LOCATION Tansley Bridge Over
Bronte Creek

Subject: Re: Additional Subsurface Investigation
Tansley Bridge Over Bronte Creek
(New W/B Bridge)
W.P. 22-69-03, Site No. 10-111
District #4, Hamilton

Subject: MINUTES OF TECHNICAL REVIEW
WORK PROJECT 22-69-01 & 03 Hwy. 5
1.90 MILES WEST OF HWY. 25
DISTRICT 4 - HAMILTON

Proposed New W.B.L. Structure
over Bronte Creek
Town of Burlington, District No.4 (Hamilton)
Hwy. No.5, W.P. 22-69-03, Site 10-111

DIST. 4		
CONT No	22-69-03	
WP	No 22-69-03	
HANSLEY BRIDGE OVER BRONTE CREEK NEW W/B BRIDGE		SHEET
GENERAL LAYOUT

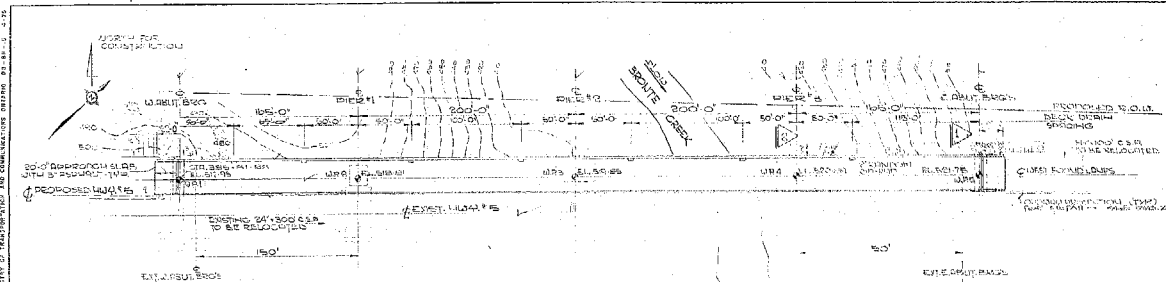
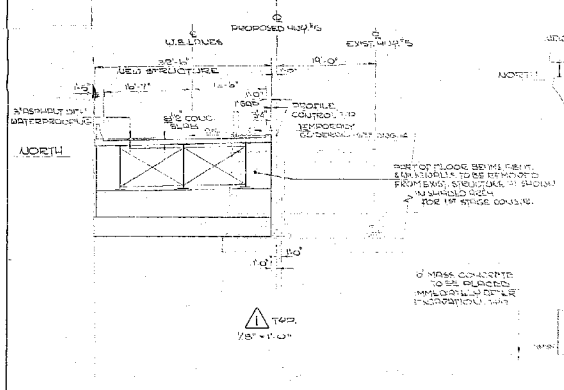
Note on section no. 2 6" mass concrete to be placed within 24 hours of excavating all piers.

General Notes - After deck slab add curbs and sidewalks.

Add note to staging drawings that bridge deck waterproofing and paving must be completed before traffic permitted on the bridge.
